PROJECT 2: DPD No. 3007492 | 1001 Mercer Street
DPD No. 3007493 | 1021 Mercer Street

03.06.2008 | Design Commission #3
LMNARCHITECTS

12/20/07 Design Commission Recommendations and Comments

ART PROGRAM: PRELIMINARY PROPOSAL

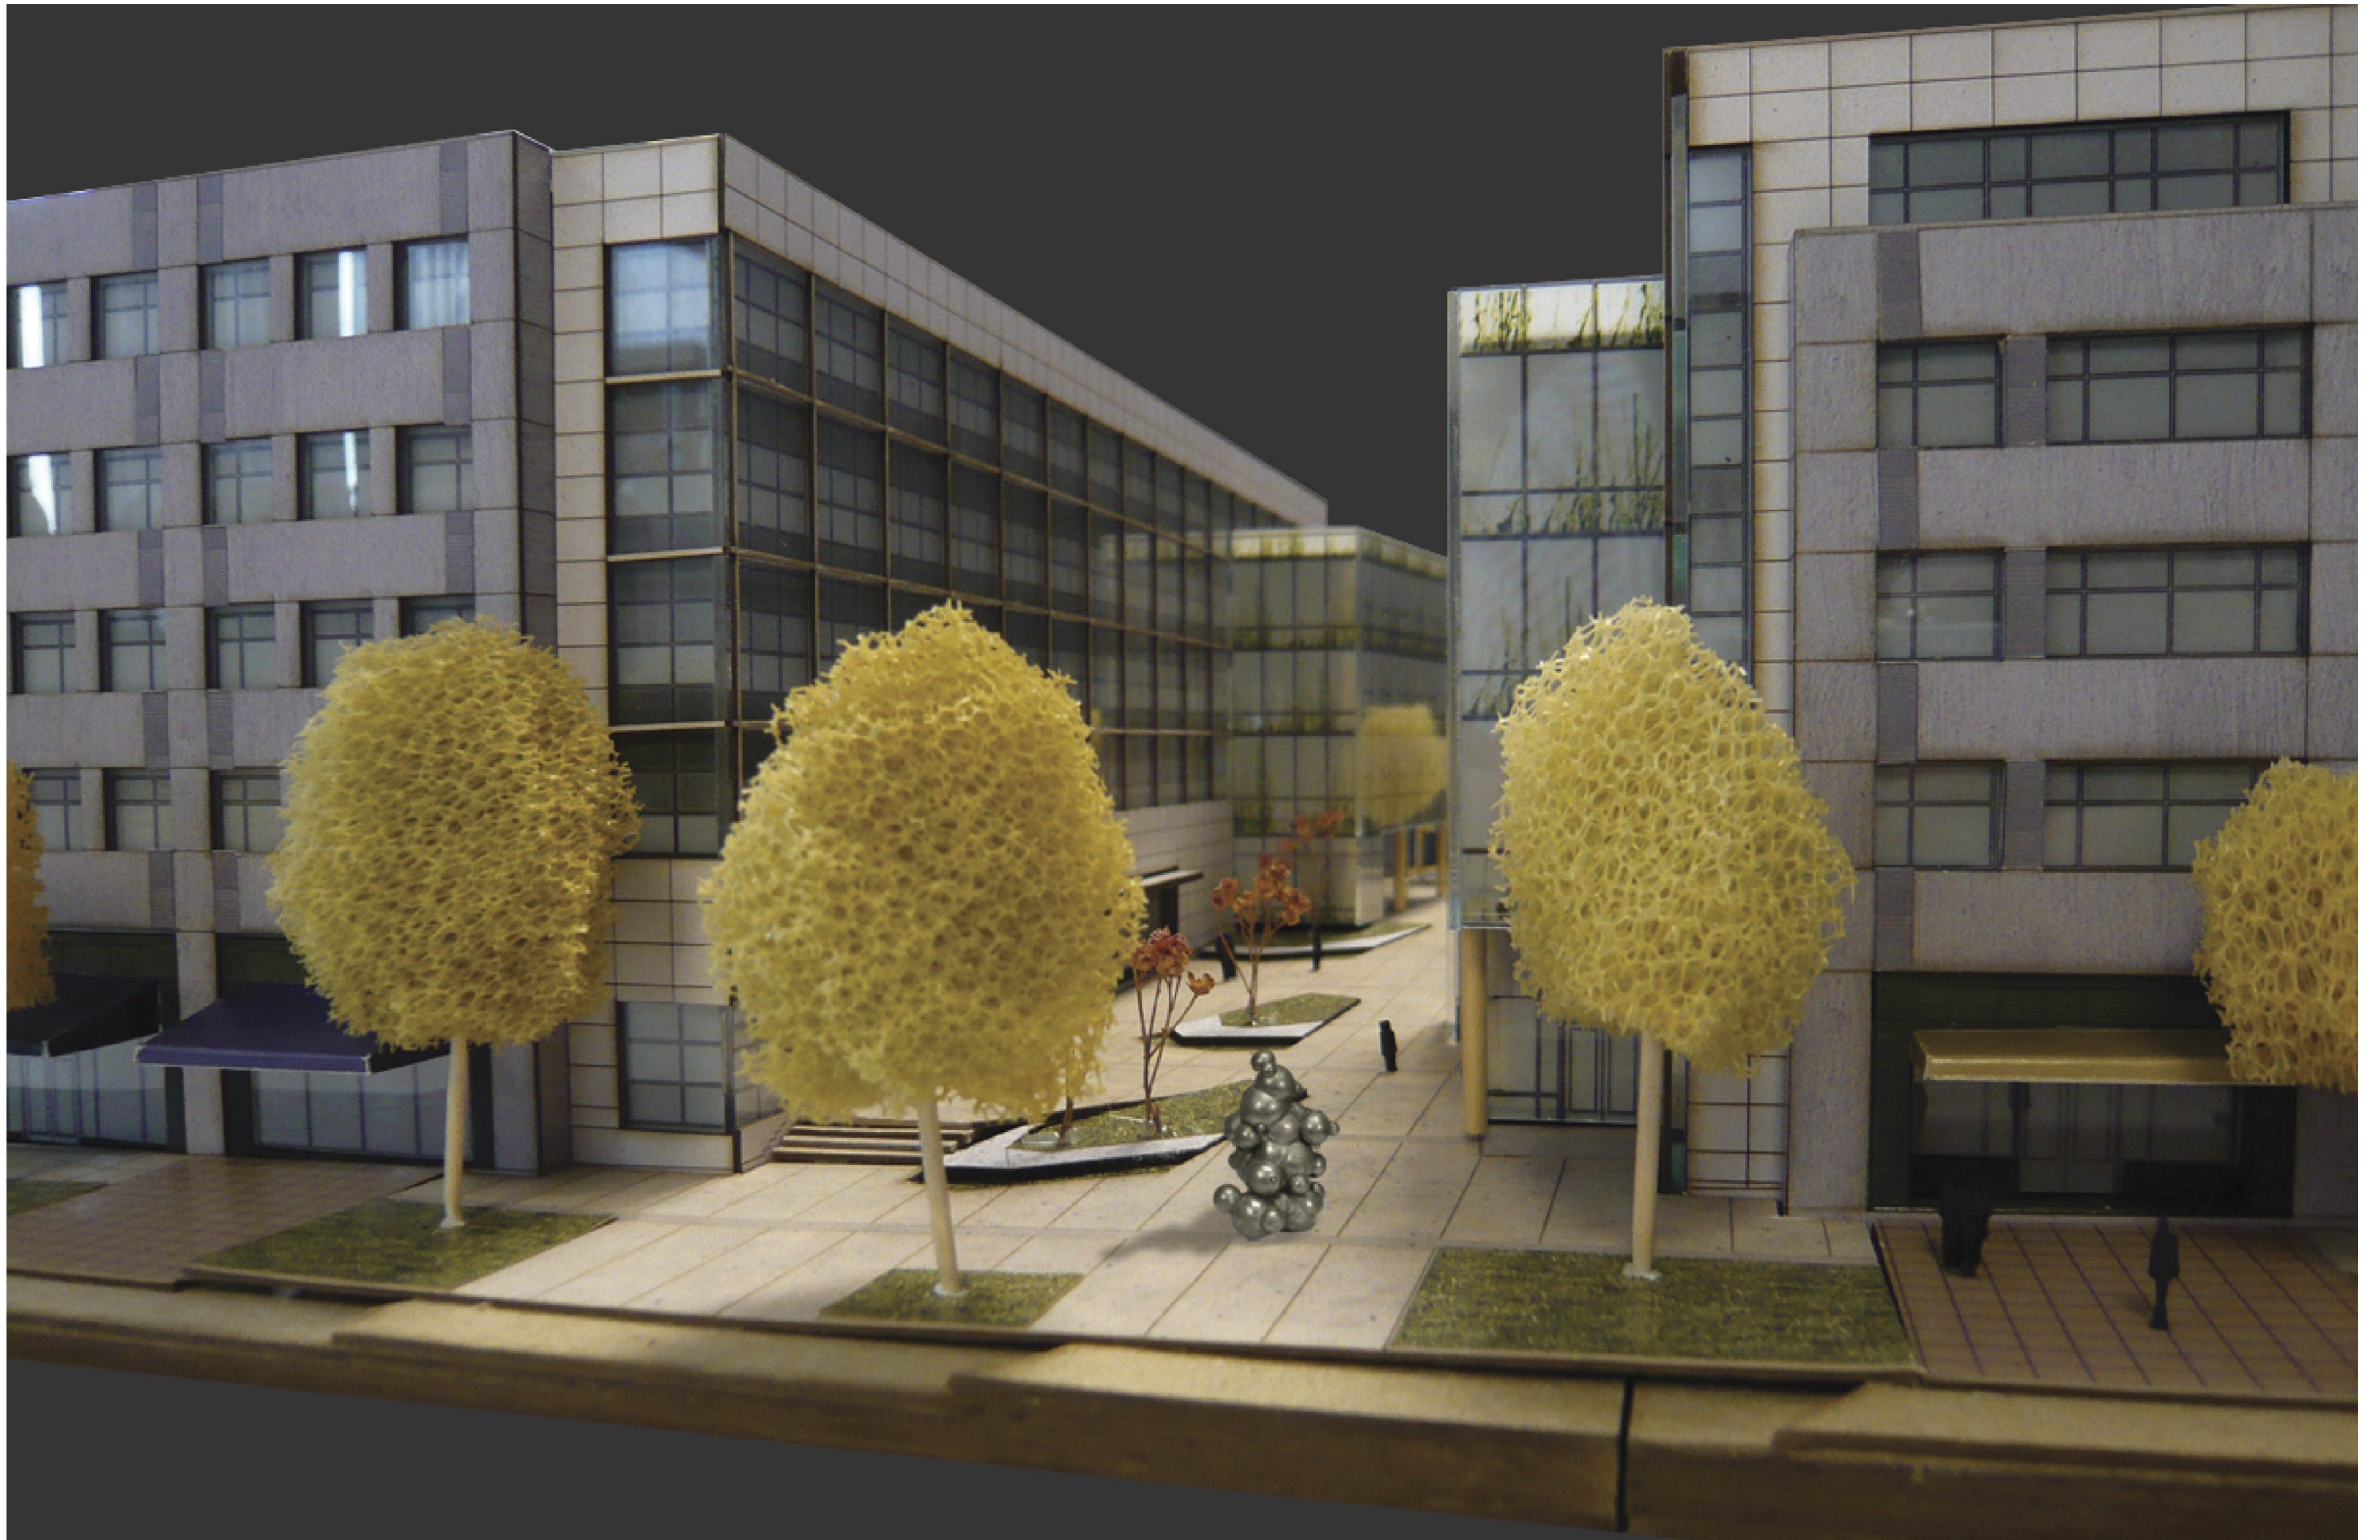
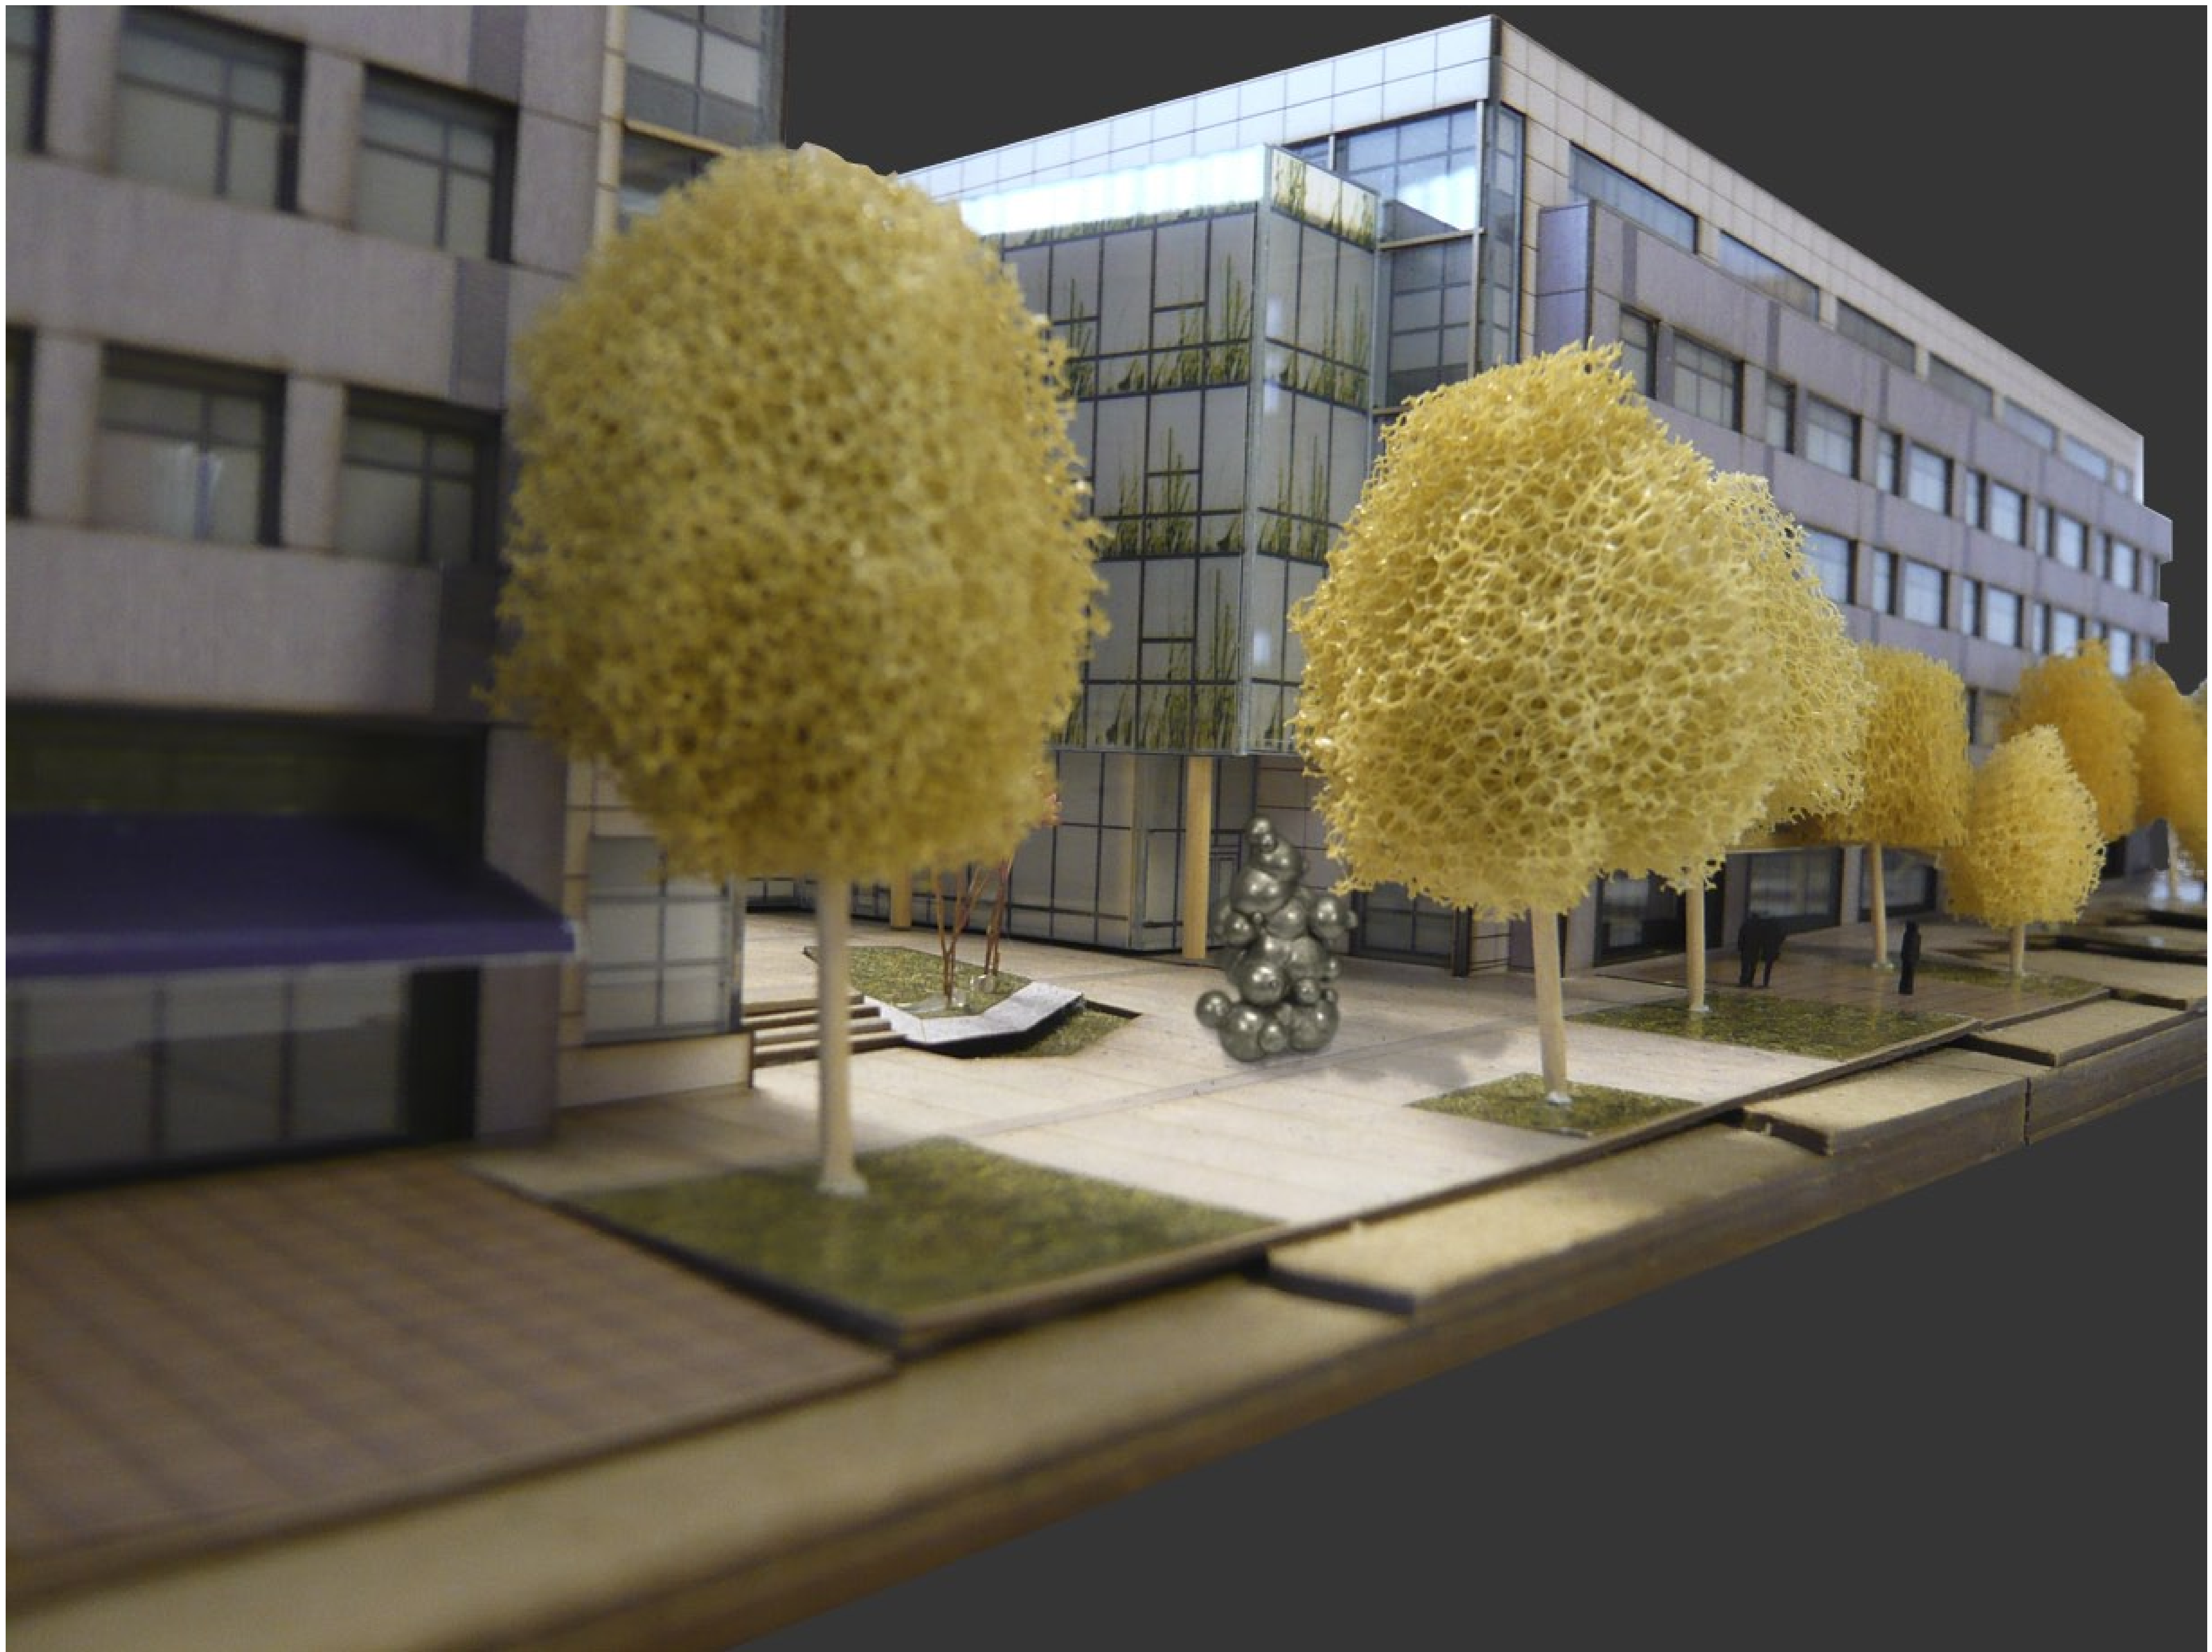
- The art program has not yet been presented, but when developed, it should serve to include the public into the space and be careful with the children’s art element.
- An artist (Jamie Walker) has been selected and a description of his preliminary concept will be included in the 3/6/08 presentation to the Commission. To avoid conflict with the artwork, the children’s art element has been eliminated.**
